# Alert Service Bulletin

**CAMERON  
BALLOONS**

(a) No.:	13
(b) Revision / Date	Revision 0 / Date 29/10/04
(b)Title:	Cracking of Weld on Triple and Quad Burner Mountings.
(c)Description:	Possible failure of weld at joint between the burner can support plate and mounting tube.
(d)Applicability:	All Shadow, Stealth and Stratus Triple/Quad Burner assemblies with gimbaled burners
(e)Effectivity:	All

**10. Figure 1:**

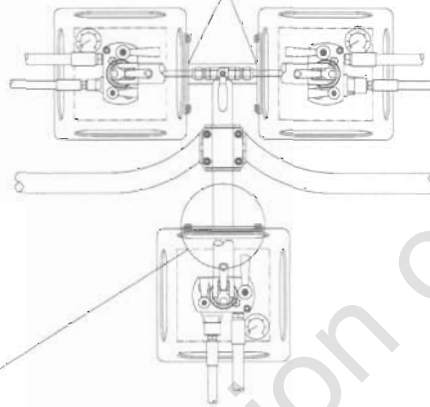
Inspect burner mounting bracket for security and correct appearance. Refer to Figure1. Non-conforming/cracked brackets must be replaced. Exchange brackets will be provided together with an instruction sheet for local replacement, or the burner can be returned to the factory. Refer to Cameron Balloons Ltd. for details.

Instructions.  
With the burner cold and all hoses disconnected/vented.  
1) Hold burner by top of coil and check for security of mounting.  
2) Visually inspect joint between burner can support plate and mounting tube. Check for visible weld bead.

Visible Weld Bead Here  
(Four positions on Quad Burner)

**Bracket With Correct Weld Bead**

**Bracket Without Correct Weld Bead**

Shadow/Shadow Stealth - Triple Bracket - CB2216, Quad Bracket - CB2252.  
Stratus- Triple Bracket CB8592, Quad Bracket -CB8596.
